ENVIRONMENTAL REVIEW TEAM REPORT

BEAVER BROOK FLOOD CONTROL PROJECT MILFORD, CT

**BEAVER BROOK FLOOD
CONTROL PROJECT
MILFORD, CT
SEPTEMBER 1984**

FIGURE 1 WATERSHED MAP

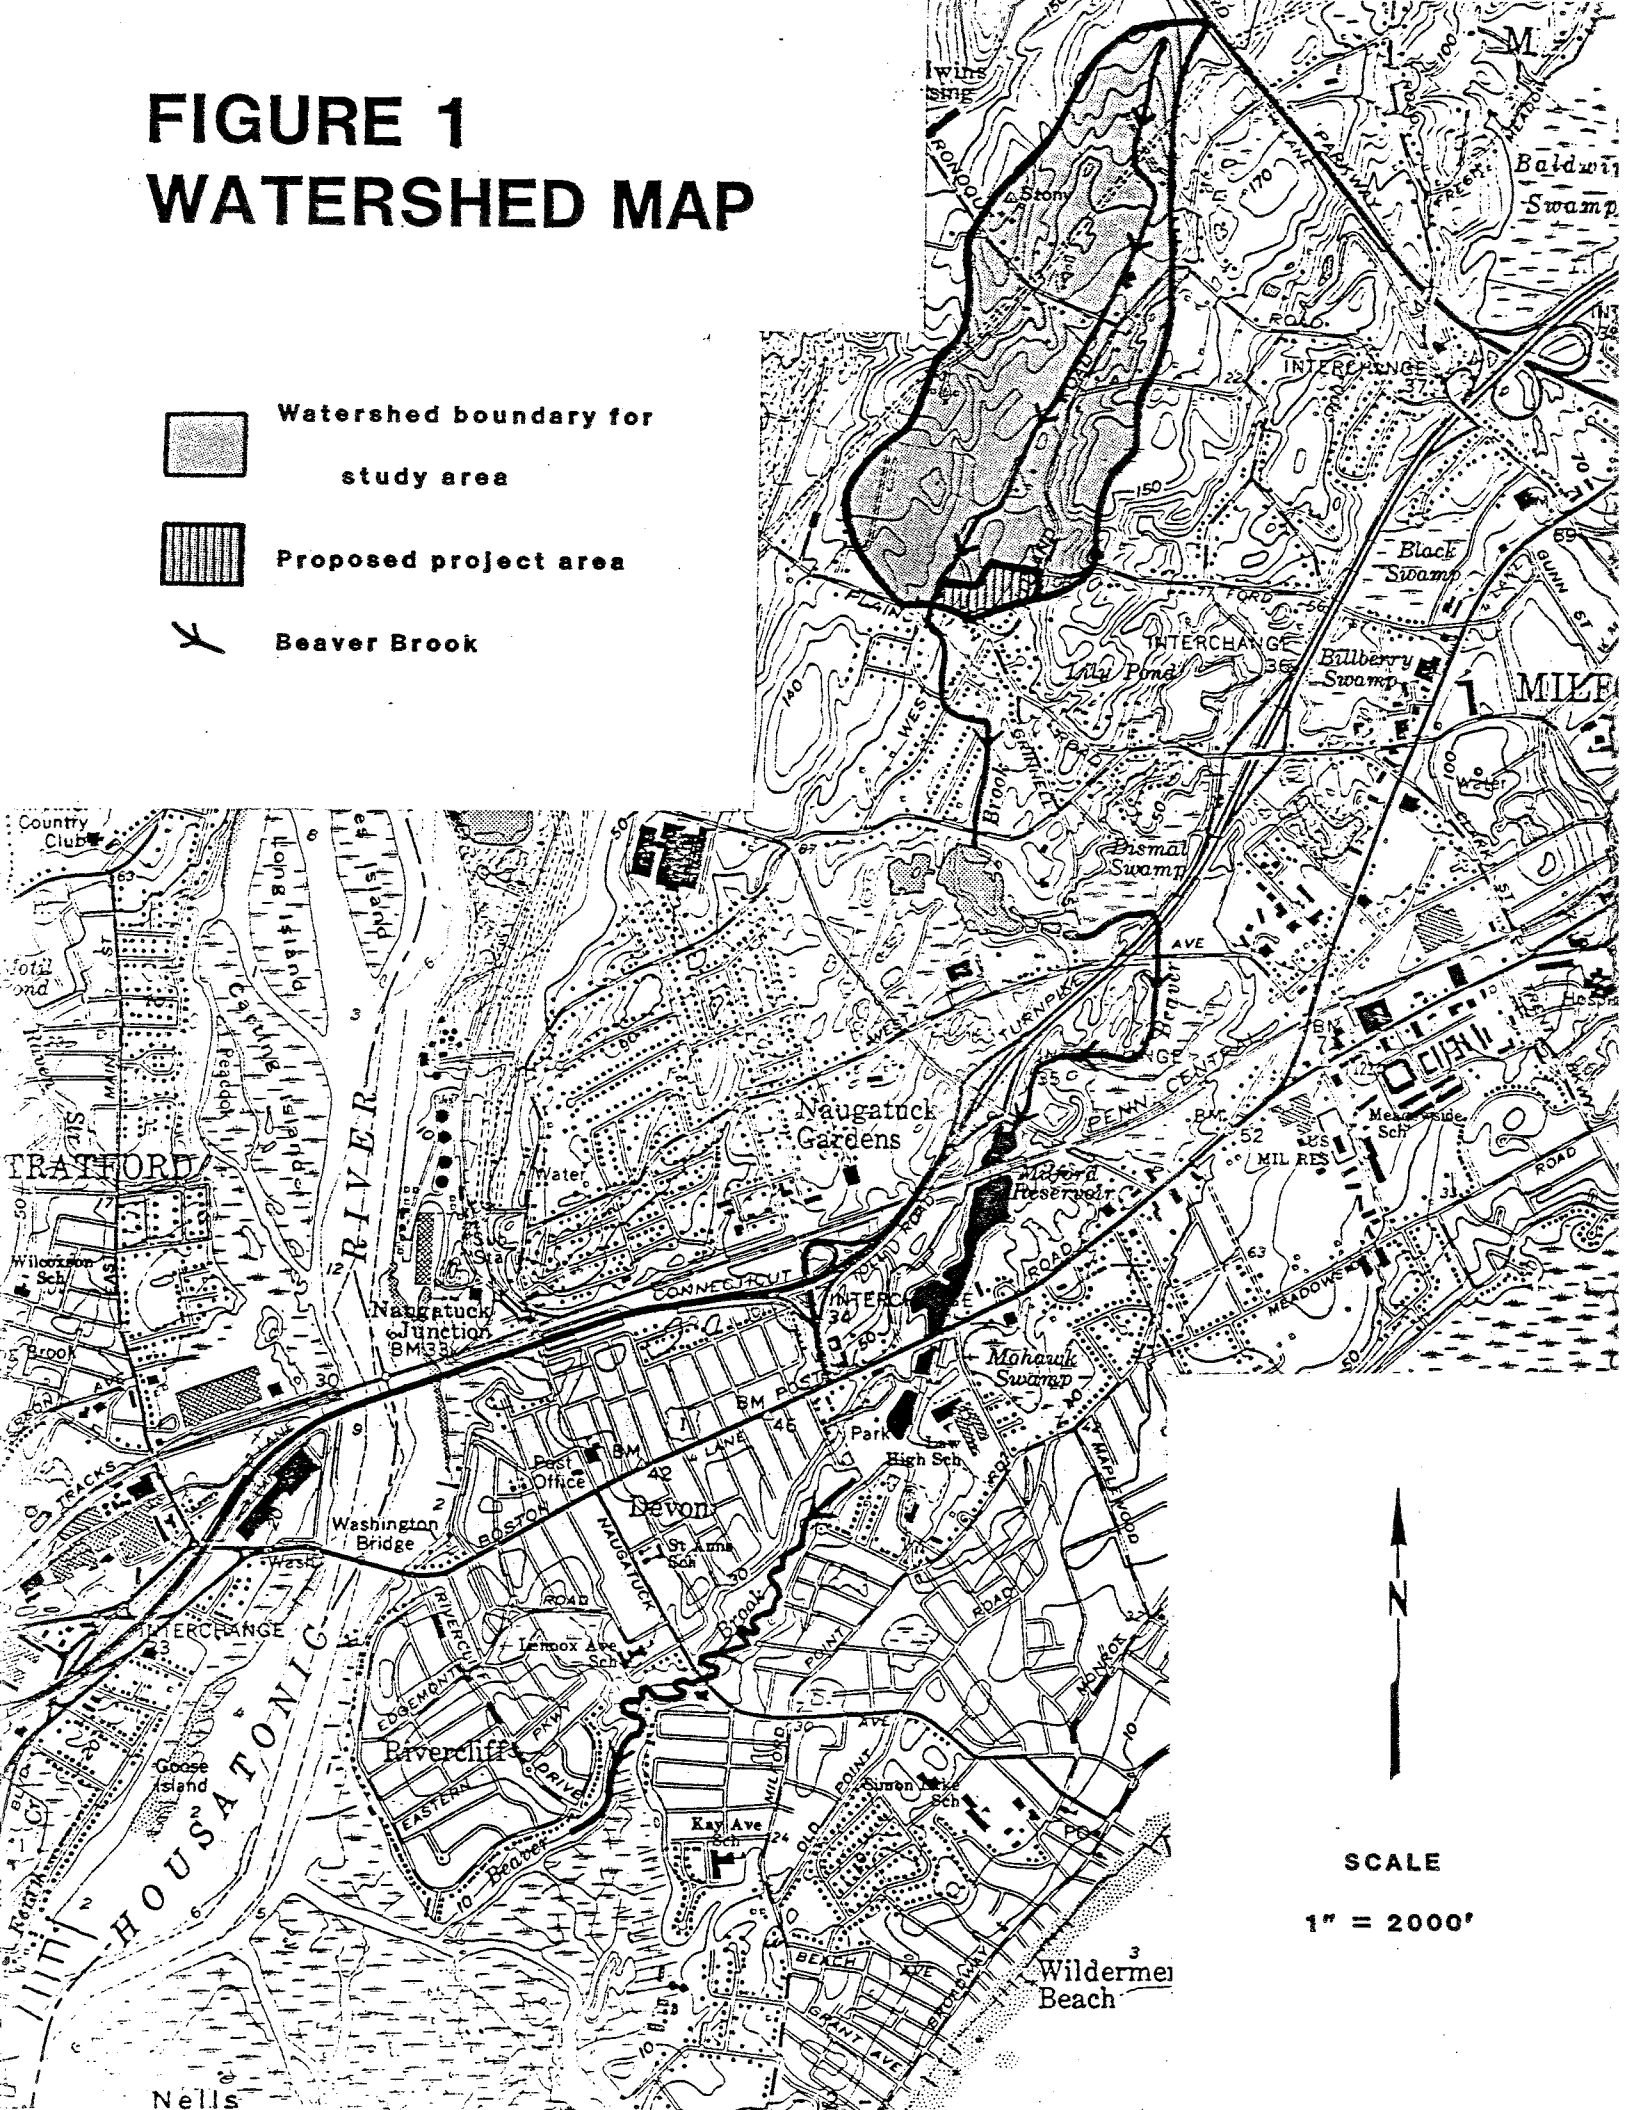
As shown in Figure 1, the watershed boundary for the study area tends to follow along the crests of local ridges and hills that divide adjacent watersheds. Theoretically, a drop of rain that falls squarely on a watershed divide has a 50-50 chance of flowing into one watershed or an adjacent one. The point of outflow (design point) chosen for this review is at the twenty-four inch culvert which passes under Plains Road. Beaver Brook bisects the watershed generally in a north-south direction. The Brook continues to flow in a southerly direction en route to Milford Reservoir where it is temporarily stored. The Brook flows from the Milford Reservoir into the Housatonic River, which ultimately empties into Long Island Sound.

FIGURE 2 PROJECT LOCATION MAP

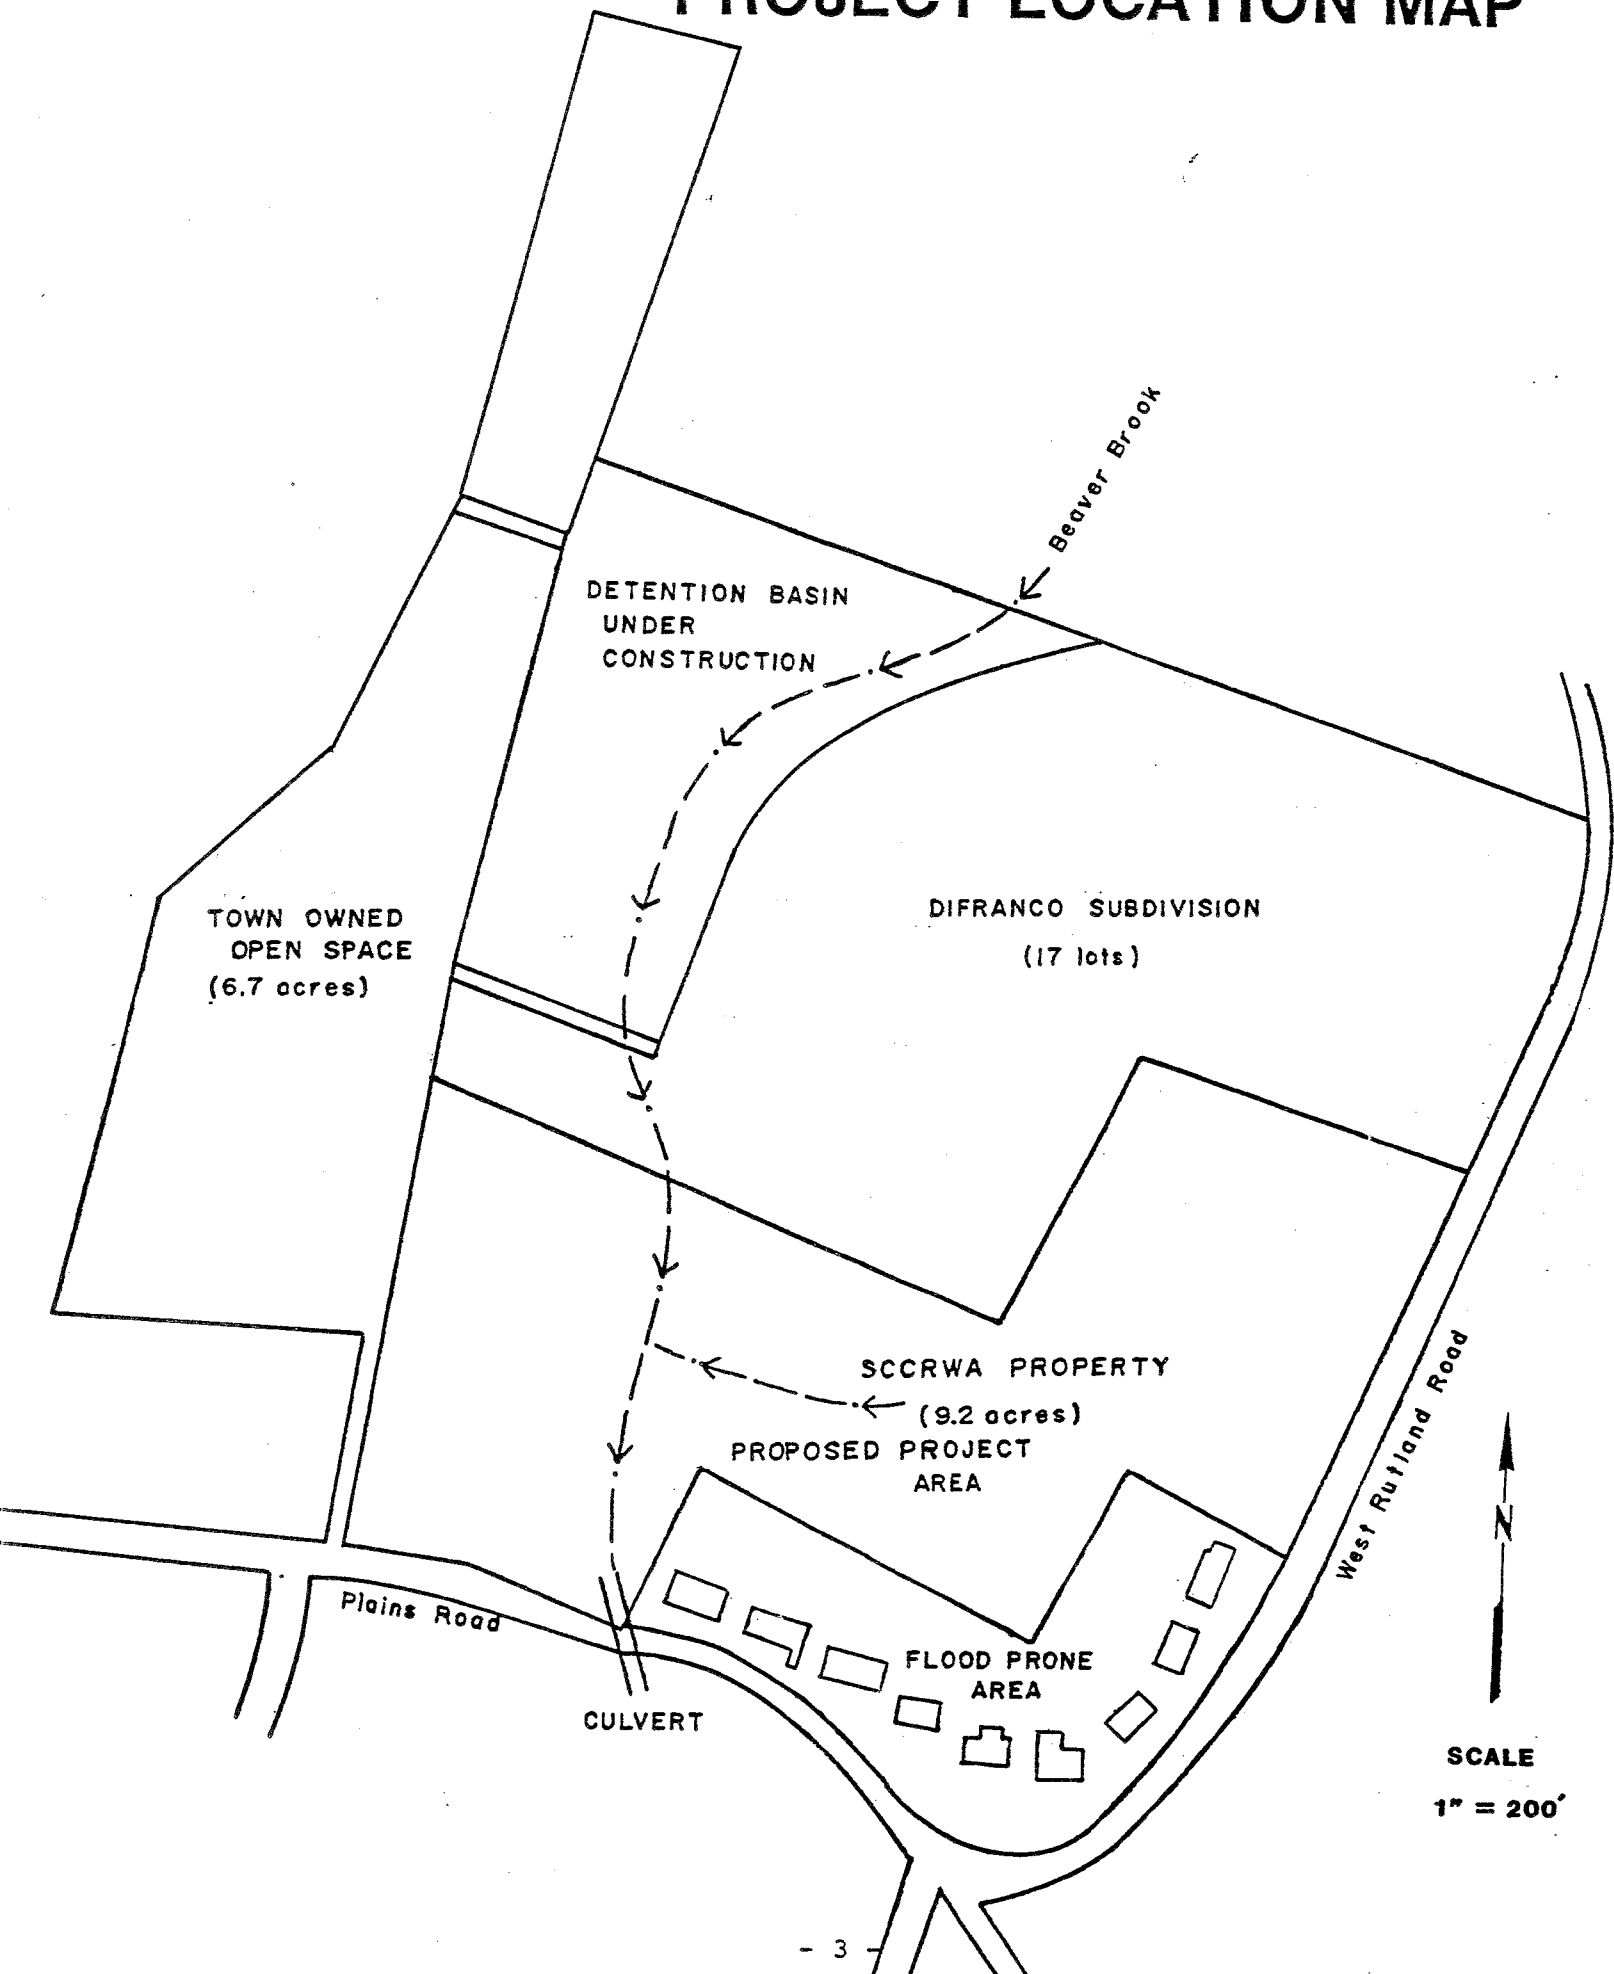
In order to effectively mitigate the flooding problems being experienced by homes fronting West Rutland Road and Plains Road (i.e., the flood-prone area on Figure 2), it appears that the construction of a channel will be required just north of the Patray residence. This channel should be grass-lined and constructed with sufficient gradient. The purpose of this channel, which would run generally east-west would be to intercept surface runoff that flows parallel to West Rutland towards the flood-prone area. Once it collects the surface water, the channel would transport the water to the proposed detention basin facility. As mentioned earlier, the presence of bedrock at or near ground surface north of the affected homes may preclude the installation of the gravity flow channel, unless it is blasted away. It appears that the construction of the opened, grass-lined channel just north of the flood-prone area would be the most effective way to mitigate the flooding problems currently being experienced by the homes. If the channel was constructed farther north, bypassing the bedrock outcrops, it may intercept some surface water flow. However, it seems likely that homes in the flood-prone areas would probably still experience some flooding problems.

FIGURE 3 BEDROCK GEOLOGY

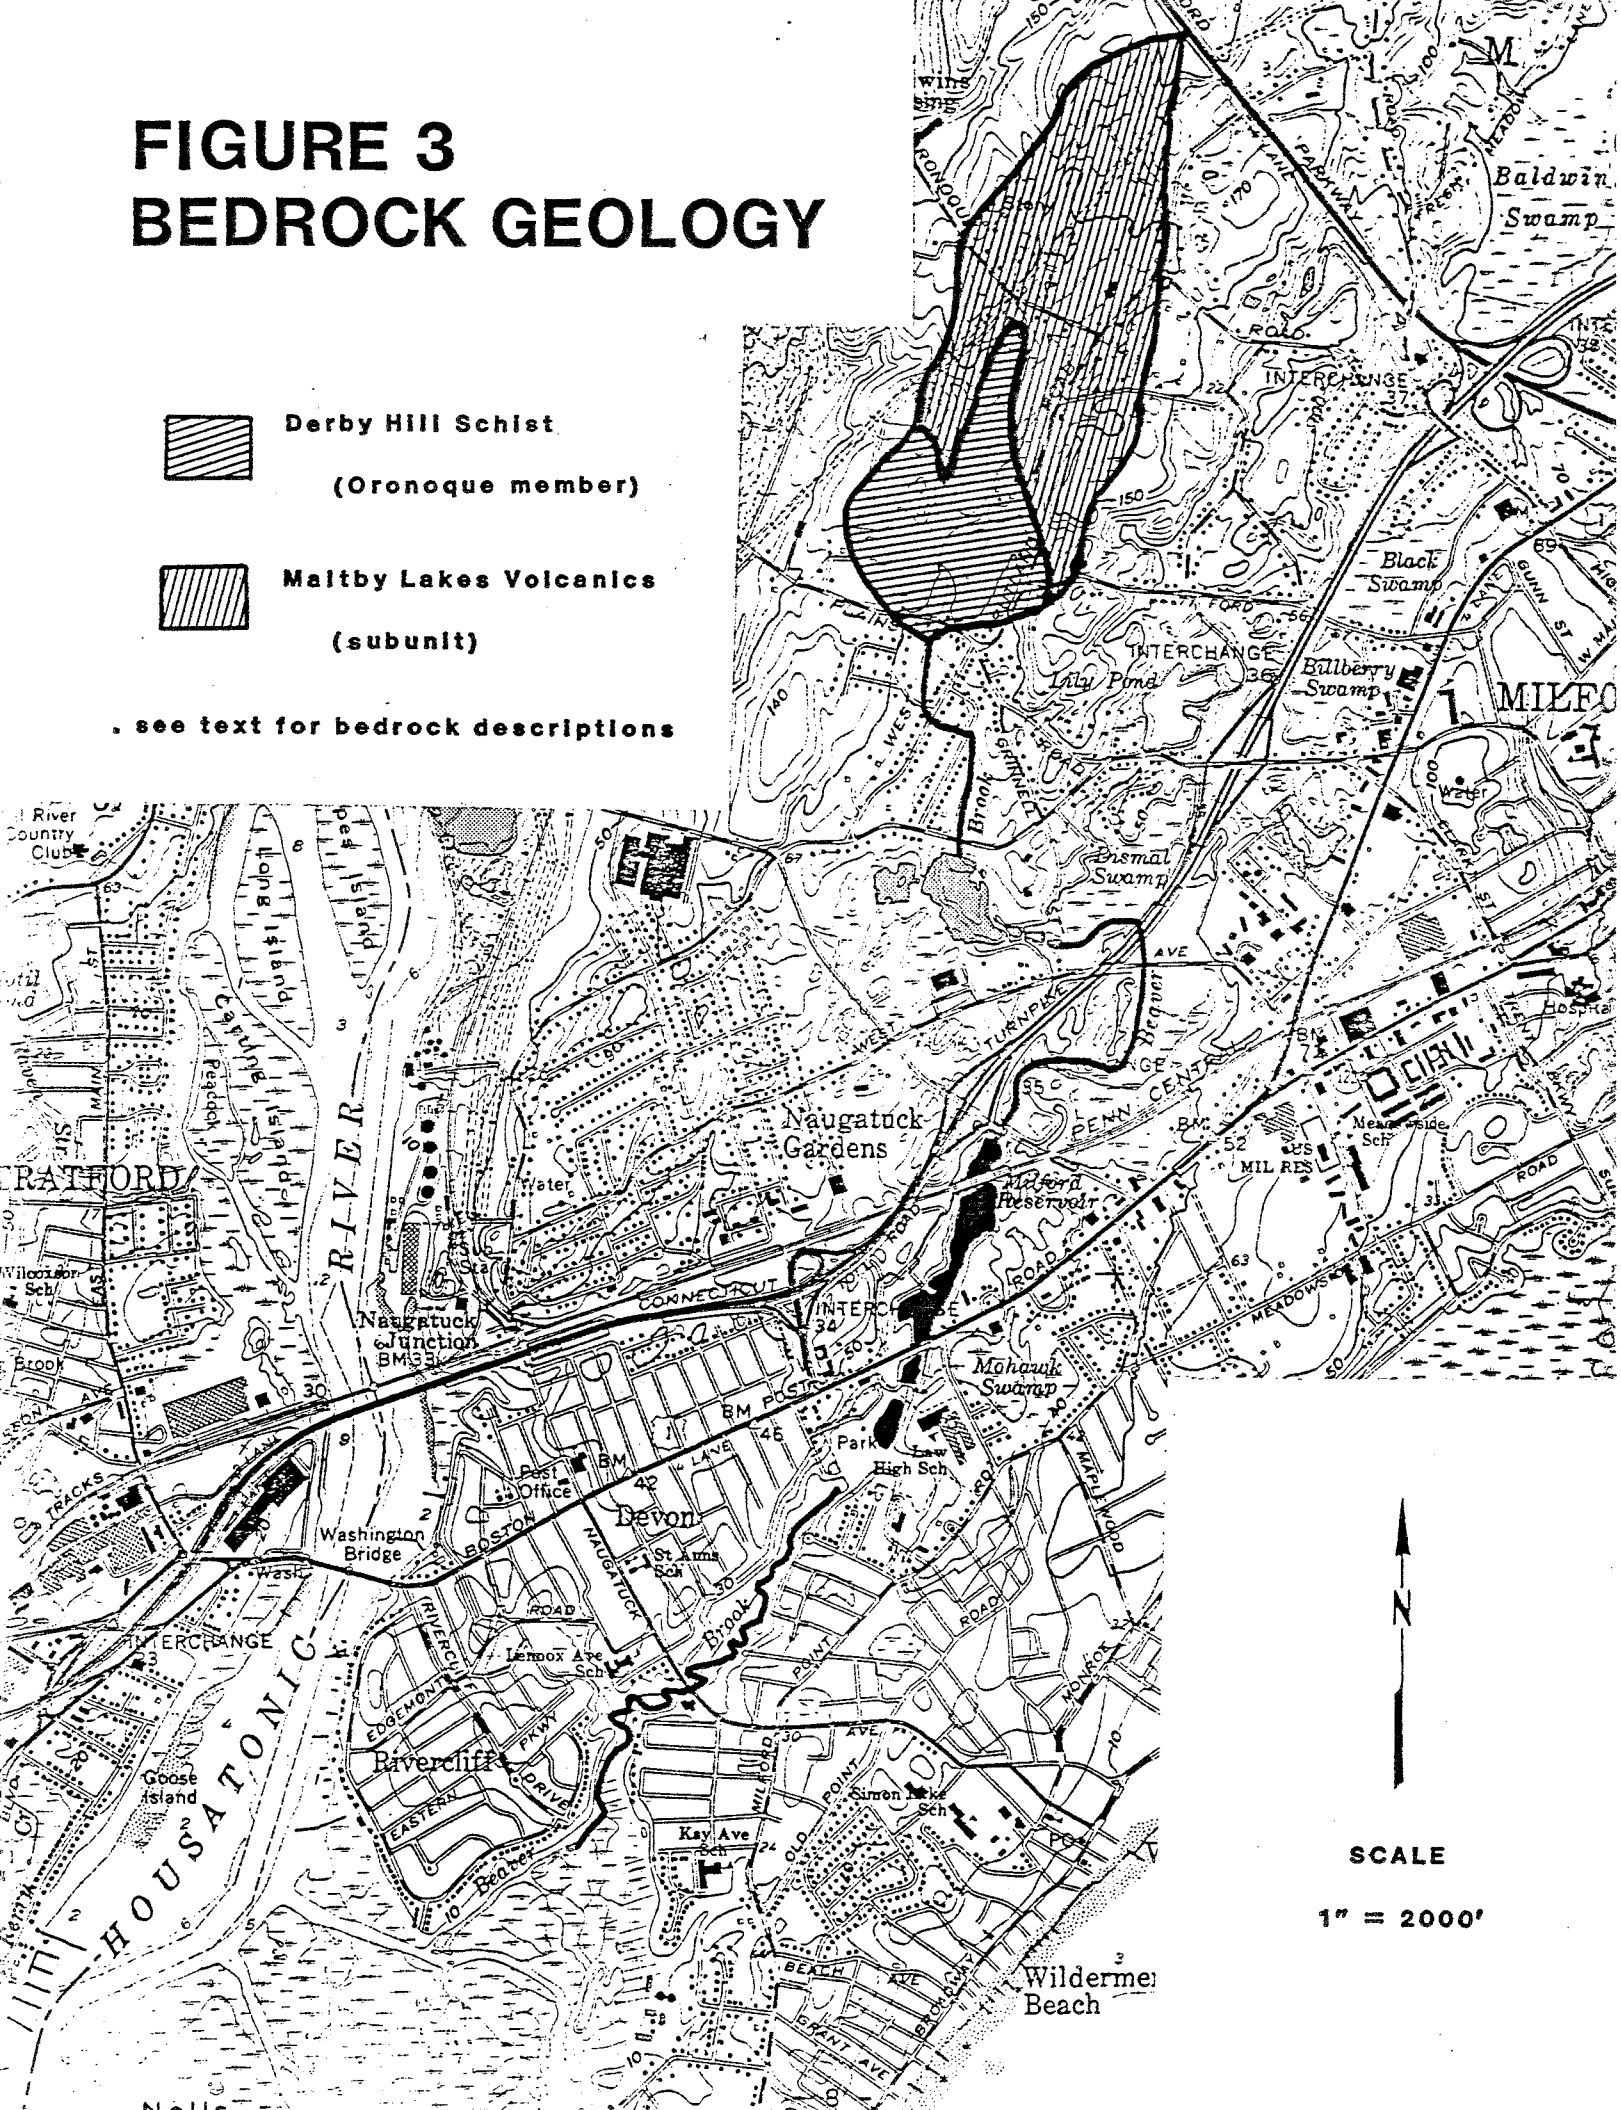
The bedrock geologic map for the Milford quadrangle (GR-427) classifies the rocks underlying and/or cropping out in the watershed as subunits of the Maltby Lakes Volcanics and Derby Hill Schist Formations (see Figure 3). The predominant rock type found in the watershed is a member of the Maltby Lakes Volcanics. This rock unit consists of medium-to-fine grained volcanic rocks which have been partly metamorphosed (i.e., altered by great heat and pressure deep within the earth's crust). "Volcanic rocks" are rocks which have been poured out or ejected at or near the earth's surface. The rock is a dark-gray to grayish-black amphibolite composed of the minerals hornblende, sodic andesine, quartz and epidote. Minor minerals include sphene, ilmenite, rutile, apatite and pyrite. The term "amphibolite" refers to a rock which is composed mainly of dark-colored minerals of the amphibole group, especially hornblende.

The Oronoque Member of the Derby Hill Schist underlies or crops out in the southern half of the watershed. The rock consists of a medium-to-fine grained, greenish-gray to medium dark-gray gneiss composed mainly of the mineral quartz and plagioclase feldspar (albite) with lesser amounts of green and brown biotite and garnet. An outcrop studded with garnet crystals is visible north of the Patry residence on West Rutland Road. Also, there are some schist layers in the rock, which contain abundant muscovite and chlorite.

A ridge of bedrock outcrop appears to run in a north-east-southwest direction in the area between the proposed detention basin and West Rutland Road. Due to the presence of bedrock, it may be necessary to blast the rocks in order to construct the channel so that water can flow by gravity to the detention basin.
